IMPROVED LOCK NUT IN GLYCOL PUMPS

Lock Nuts Changed from 1140 to 1140X

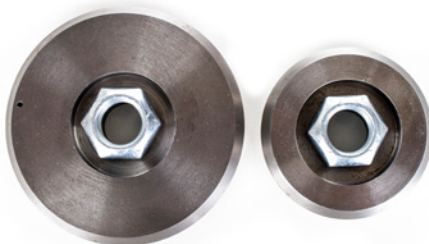
This product update is to inform you that we are changing the 1140 lock nut to the 1140X.

The 1140X is a reliable off-the-shelf alternative to the 1140 custom lock nut. We've made this change to resolve a concern where the threads on the piston rod of 45020 PV and 20020 SC glycol pumps have been damaged during routine maintenance.

Old Part Number: 1140

Will remain in Repair Kits until 4/1/2021
Requires 1-1/4" Socket

New Part Number: 1140X

Now Standard in 45020 PV and 20020 PV Glycol Pumps
Standard in Repair Kits after 4/1/2021
Requires a larger 1-5/16" Socket

All 1147 (GAJ Models) and 1508 (GAK Models) produced after 9/2019 have been reworked to accommodate the larger 1-5/16" socket.

Note: If the pistons in your pump have not been replaced since 9/2019 and you need to install the new 1140X lock nut, it will require the installation of the new (reworked) piston.
